UNITED STATES PATENT AND TRADEMARK OFFICE

APPLICATION NO.	FILING DATE	FIRST NAMED INVENTOR	ATTORNEY DOCKET NO.	CONFIRMATION NO.
10/806,720	03/23/2004	Diane Ransom	04-007-DR	2656

Office Action Summary

DETAILED ACTION

FIG. 4

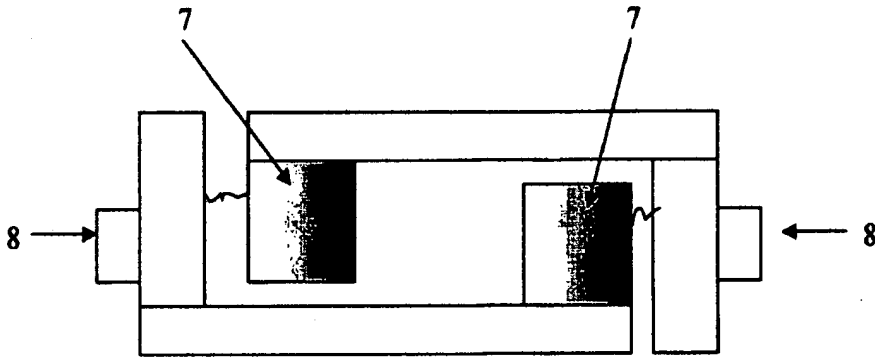
The drawings filed on 19 September 2005 have not been approved for entry due to New matter presented in the proposed Figs. 4 and 5. The structure represented in Figs. 4 and 5 has not been supported in the originally filed disclosure.

1) Applicant has not demonstrated that the details shown in new Figs 4 and 5 were exclusively well known in the button (i.e., garment fastener) art. Applicant has not provided an factual evidence to support the details shown in new Figs 4 and 5 were exclusively well known in the button (i.e., garment fastener) art.

*Do not Enter -
New Matter - S/P
Not Approved*

Applicant is required to cancel the new matter in the reply to this Office action.

FIG. 6

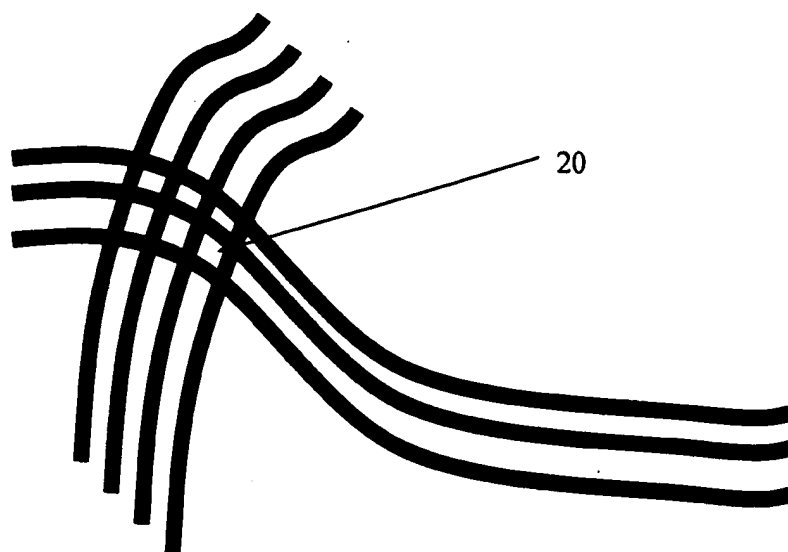
In view of applicant's submission of new drawing Figs. 6 and 7 including drawing features pertaining to "a piece of apparel" (claim 20), "inserting said post through a pre-existing opening in the fabric" (claim 21), and "a plurality of fibers" (claim 22), these specific drawing objections indicated in the prior Office action have been withdrawn.
